UNITED STATES PATENT AND TRADEMARK OFFICE

Office Action Summary

10/712,286

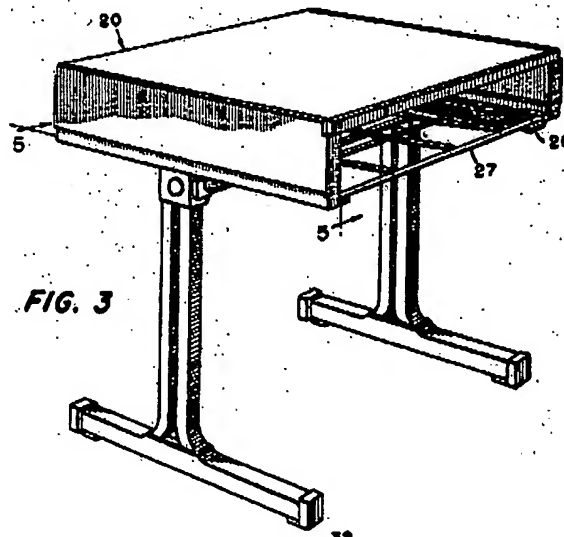
3. The drawings are objected to under 37 CFR 1.83(a). The drawings must show every feature of the invention specified in the claims. Therefore, the details of the first and second sections as shown in figures 1-3 must be labeled (following an updated description describing the elements as claimed) or the feature(s) should be canceled from the claim(s). No new matter should be entered.

Corrected drawing sheets in compliance with 37 CFR 1.121(d) are required in reply to the Office action to avoid abandonment of the application. Any amended replacement drawing sheet should include all of the figures appearing on the immediate prior version of the sheet, even if only one figure is being amended. The figure or figure number of an amended drawing should not be labeled as "amended." If a drawing figure is to be canceled, the appropriate figure must be removed from the replacement sheet, and where necessary, the remaining figures must be renumbered and appropriate changes made to the brief description of the several views of the drawings for consistency. Additional replacement sheets may be necessary to show the renumbering of the remaining figures. Each drawing sheet submitted after the filing date of an application must be labeled in the top margin as either "Replacement Sheet" or "New Sheet" pursuant to 37 CFR 1.121(d). If the changes are not accepted by the examiner,

Barecki ('182) Fig. 3

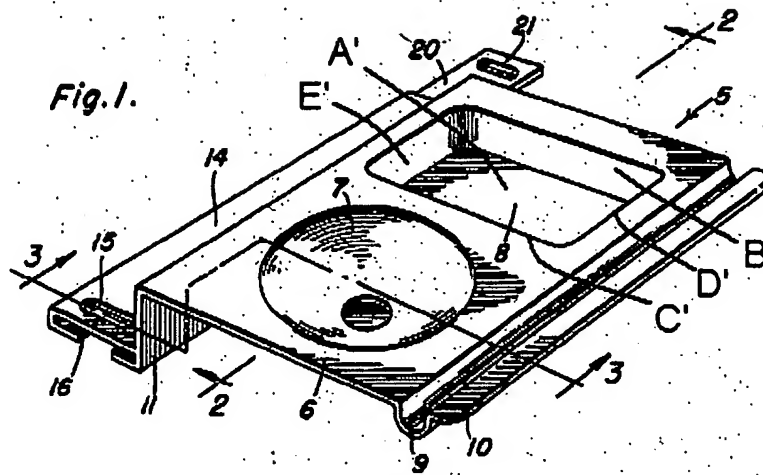
4. Claims 15 and 16 are rejected under 35 U.S.C. 103(a) as being unpatentable over US Patent 3,758,182 to Barecki in view of US Patent 2,535,743 to Lundahl and US Patent 6,056,178 to Rapp-Duncan. . Barecki ('182) teaches in Fig. 3, a desk (20) with a top (21) and a support structure (24). The desk (20) is bottomless with support runners (26) that define the front opening. The runners (26) support a bottom rack (27), which is made of wire mesh and has many openings. In figures 6 and 7 Barecki teaches a pencil case (28) that could replace the bottom rack (27) on the desk and thus is teaching a desire to have a pencil case in that location.

5. Barecki ('182) does not disclose expressly a pencil case attached with a pencil case attachment plate to the bookrack, a portion of the pencil case being disposed below the bottom wall of the book rack, and the pencil case with a bottom wall, a pair of opposed side walls, a front wall and a rear wall.
